AGENDA – Planning Commission Meeting

CITY OF SARATOGA SPRINGS

Major Site Plan Amendment Thrive Drive Daycare September 11, 2025 Public Meeting

**Major Site Plan Amendment
Saratoga Springs Commercial Plat F Lot 607
September 11, 2025
Public Meeting**

1 NORTH ELEVATION

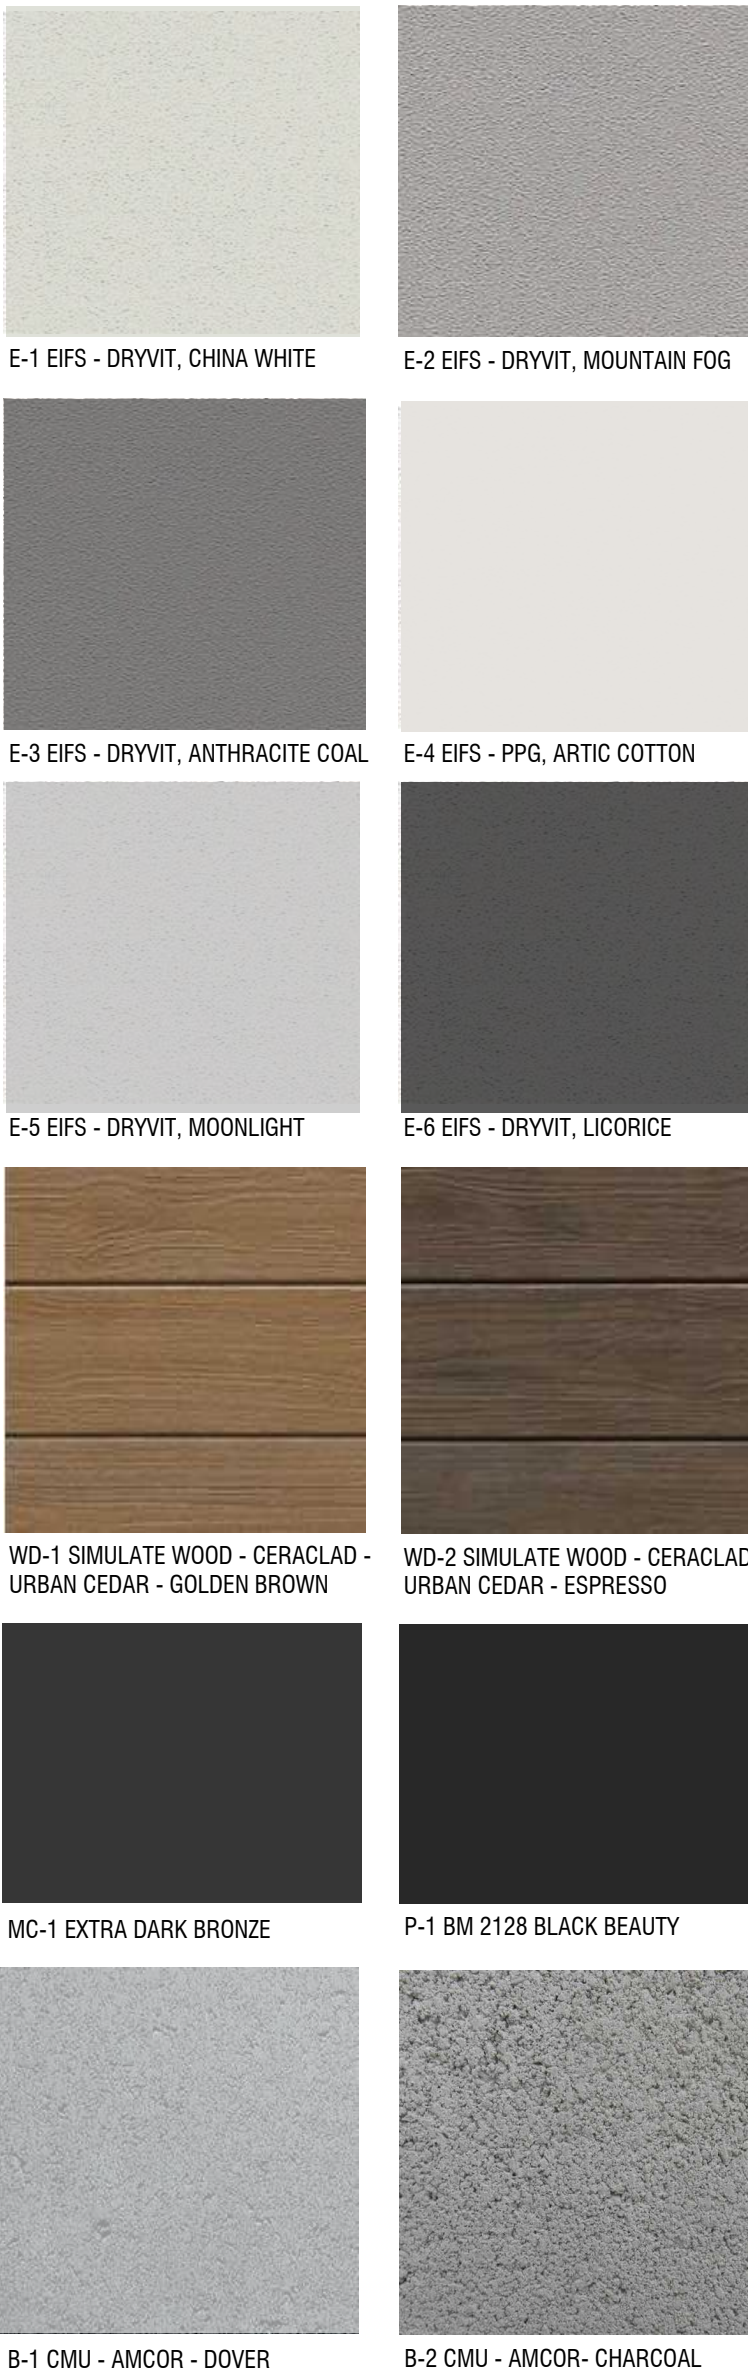
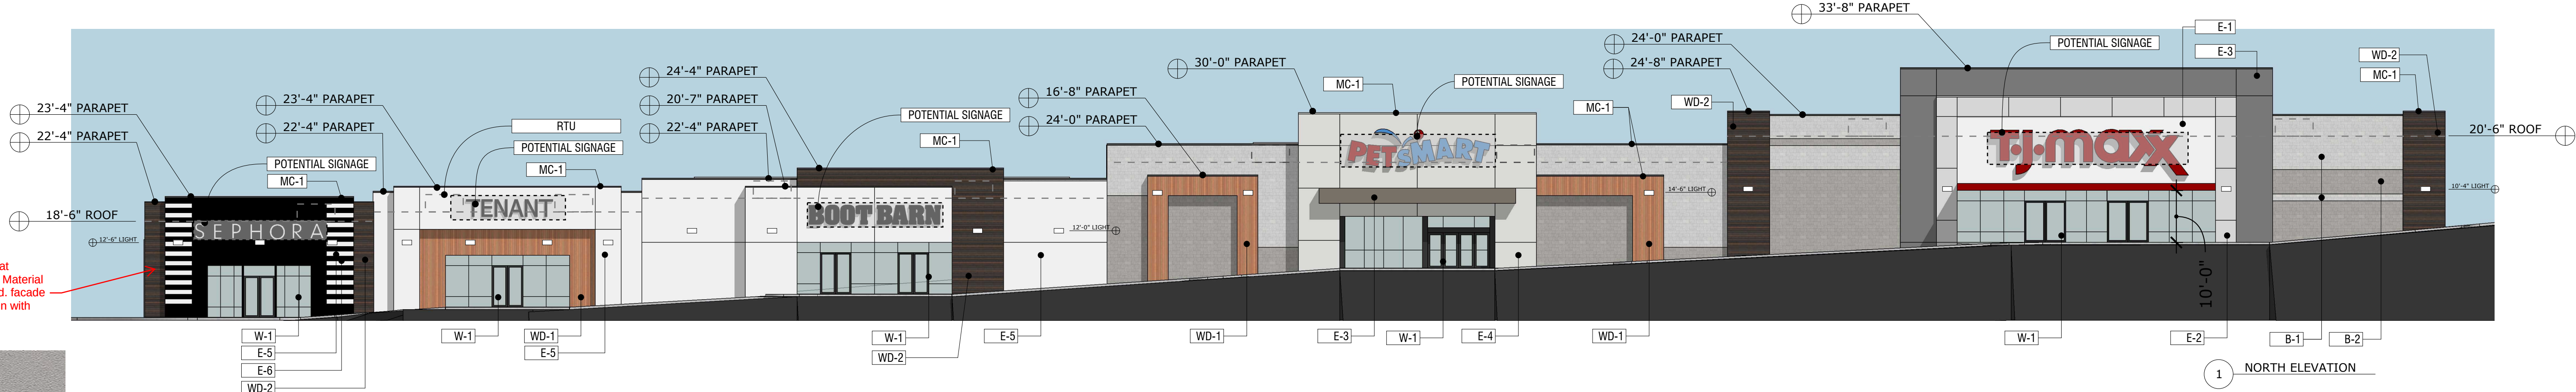
On August 8, 2025, the City received an application for a Site Plan Amendment following the code compliance review of a Tenant Improvement (TI) building permit by planning staff. It was determined that the exterior elevation differed from the site plan approved by the City Council on October 15, 2024, necessitating a major site plan amendment. Specifically, two EIFS colors were revised on the Sephora elevation and placement of the colors has changed. The attached

elevations show the original in the upper left corner.

Cloud represents minimal area that changed from the original review. Material percentages remained unchanged. Facade design was adjusted to better align with tenant's required branding.

1. The elevations are recommended as shown in the attachments to the Staff report.
2. All other Code requirements shall be met.
3. Any other conditions or changes as articulated by the Planning Commission:
 - a. _____.
